## **Reliability Analysis Update**

Transmission Expansion Advisory Committee July 9, 2024

- 2024 Window 1 Updates
- 2023 Window 2 Projects 2<sup>nd</sup> Read
- 2022 Window 3 Scope Changes

## 2022 RTEP Window 3 Solution: 502 Jct-Woodside-Aspen 500 kV & Doubs Corridor Projects

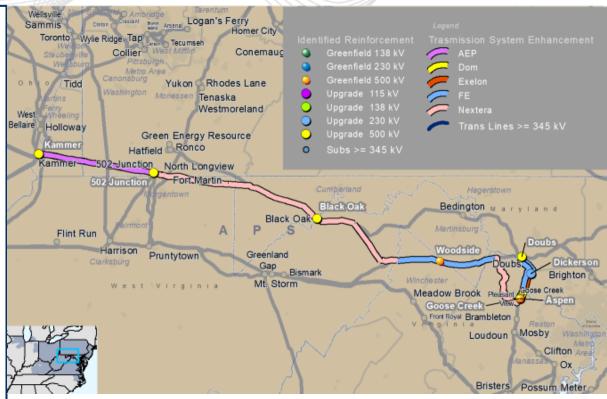
- **b3800.102:** New 500 kV line from existing 502 Junction substation to New Stonewall/Woodside substation (bypass Black Oak) \$315.64M
- **b3800.106 b3800.110:** Woodside substation adjacent to existing Stonewall 138 kV substation \$80.01M
- b3800.113, b3800.115, b3800.117: Woodside reactive components, and NEET scope for Doubs to Bismark line terminations into Woodside - \$45.24M
- b3800.119: New 500 kV transmission line from Woodside substation to Aspen substation (in DOM zone). (NEET Portion) - \$71.72M

- b3800.101: 502 Junction substation two 500 kV circuit breaker expansion \$30.60M
- b3800.103: Rebuild ~16 miles of the Gore-Stonewall 138 kV line with 500 kV overbuild \$151.72M
- **b3800.104**: Rebuild ~15 miles of the Stonewall-Millville 138 kV line with 500 kV overbuild \$136.93M
- b3800.105: Rebuild ~6 miles of the Millville-Doubs 138 kV line with 500 kV overbuild \$52.35M
- b3800.111, b3800.112, b3800.114 : Woodside-Stonewall 138 kV lines 1&2 and Stonewall 138 kV substation two 138 kV breaker expansion - \$20.89M
- **b3800.116:** FE scope for terminating Doubs to Bismark line into Woodside 500 kV substation \$0.06M

- b3800.118: DOM scope for terminating Doubs to Bismark line into Woodside 500 kV substation \$5.10M
- **b3800.120:** Terminate new NextEra 500 kV line from Woodside into Aspen substation. Include a portion of the Aspen 500 kV substation build \$30.49M

## 2022 RTEP Window 3 Solution: 502 Jct-Woodside-Aspen 500 kV &

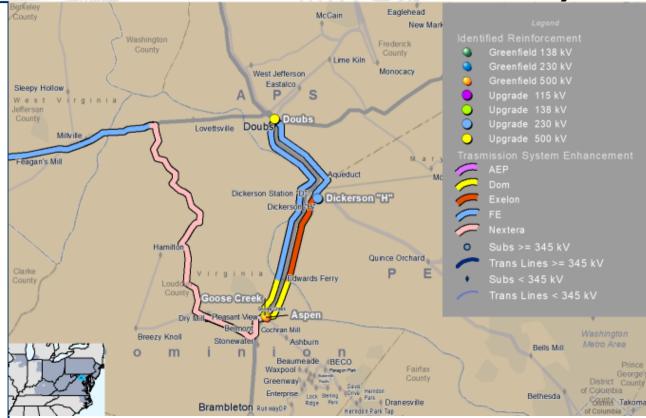
No significant scope/cost changes to the approved FE, Exelon and Dominion projects in Doubs Corridor beyond considerations to ensure sufficient space for the new Woodside – Goose Creek 500 kV line within the Corridor.

#### Net Cost Change to Doubs Corridor RTEP Projects: \$0

# Scope Changes: 502 Jct-Woodside-Aspen 500 kV & Doubs Corridor Projects

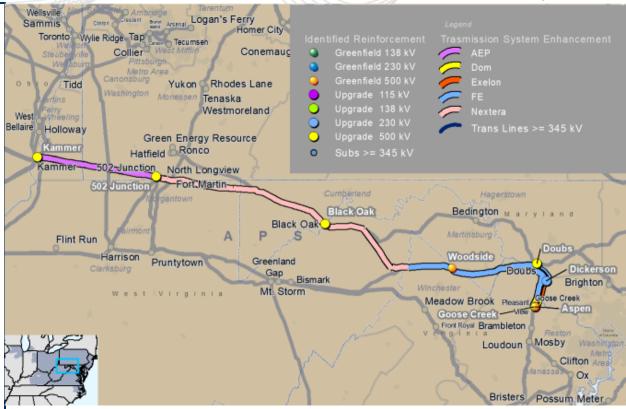
The line section from Woodside to Aspen will be rerouted from the originally proposed greenfield line route to an alternate route within existing transmission line rights of way along the Doubs Corridor containing the rebuilt Doubs – Goose Creek and the new Doubs – Aspen 500 kV lines. This reroute is the outcome of successful collaboration between NextEra and the incumbent Transmission Owners to determine the most feasible route and minimize area impact for the new Woodside to Aspen 500 kV line segment.

As part of this change, the new 500 kV line from Woodside will now terminate into Goose Creek substation due to space constraints within the Corridor and also to minimize unnecessary line crossings.

Cancel b3800.119: New 500 kV transmission line from Woodside substation to Aspen substation (in DOM zone) (NEET Portion) -\$71.72M

- Scope Change for b3800.105: Rebuild Millville-Doubs 138 kV for ~16 miles from structure MVF1-39 to structure MVF1-101(outside of Doubs Substation) with 500 kV overbuild - \$147.45M
- New Baseline Project b3800.128: Construct 500 kV Line from existing structure MVF1-101 on the Doubs – Millville 138 kV Line, around Doubs Substation, and into the entrance of the Doubs – Goose Creek Corridor. (~2 miles) - \$13.20M
- New Baseline Project b3800.129: Construct new Woodside Goose Creek 500 kV line for ~15 miles on single circuit monopole structures within the Doubs Goose Creek Corridor. (FE Portion) \$115.30M
- Revised FE Total Cost: \$616.15, Delta: +\$223.60M

Revised NextEra Total Cost: \$440.89M, Delta: -\$71.72M

## Scope Changes: 502 Jct-Woodside-Aspen 500 kV & Doubs Corridor Projects

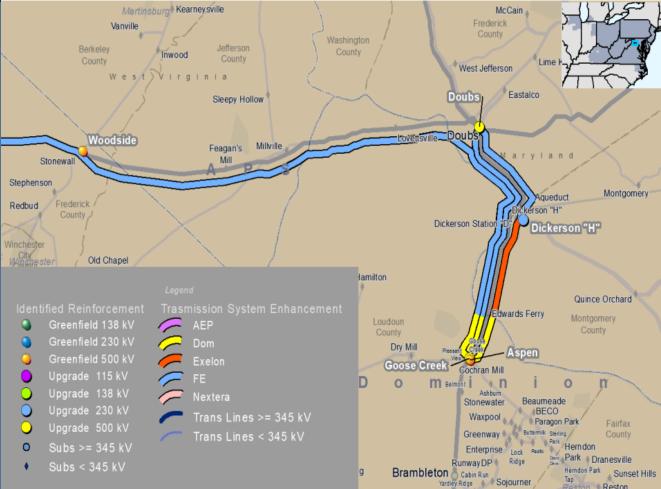
- Scope Change for b3800.120: Terminate new NextEra 500 kV line from Woodside into Goose Creek substation. The Goose Creek 500kV cap bank will be moved to Aspen substation. - \$30.49M (No Cost Change)
- New Baseline Project b3800.375: Construct new Woodside Goose Creek 500 kV line for ~3 miles on single circuit monopole structures within the Doubs – Goose Creek Corridor. (DOM Portion) - \$15.60M
- Revised DOM Total Cost: \$51.19, Delta: +\$15.60M

Net Cost Change to 502 Jct – Woodside – Aspen Projects: +\$167.48M
